Product Change Notification / MFOL-28UNFU344

CCB 5003 Final Notice: Qualification of FH-SC13/HR-5104 as new die attach material and G700LTD mold compound for selected Atmel ATA5577M1330C-UFQW and ATA5577M133DC-UFQW catalog part numbers (CPN) available in 2L XDFN (1.5x2x0.37mm) package at NSEB assembly site.

PCN# LIAL-07RPOQ740

Pre Change

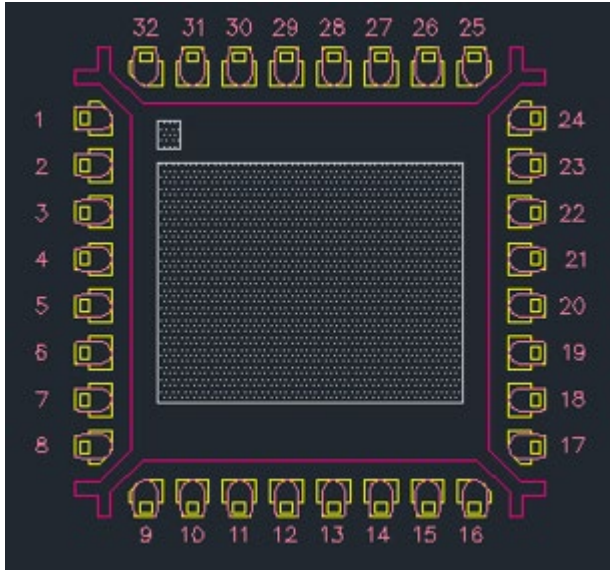
Lead frame DAP surface prep

Ag selective plating

Post Change

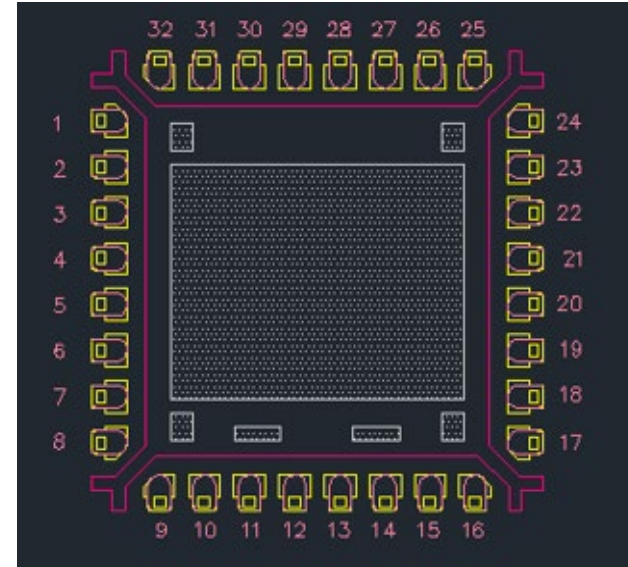
Lead frame DAP surface prep

Ag selective plating
(Add more Ag area)
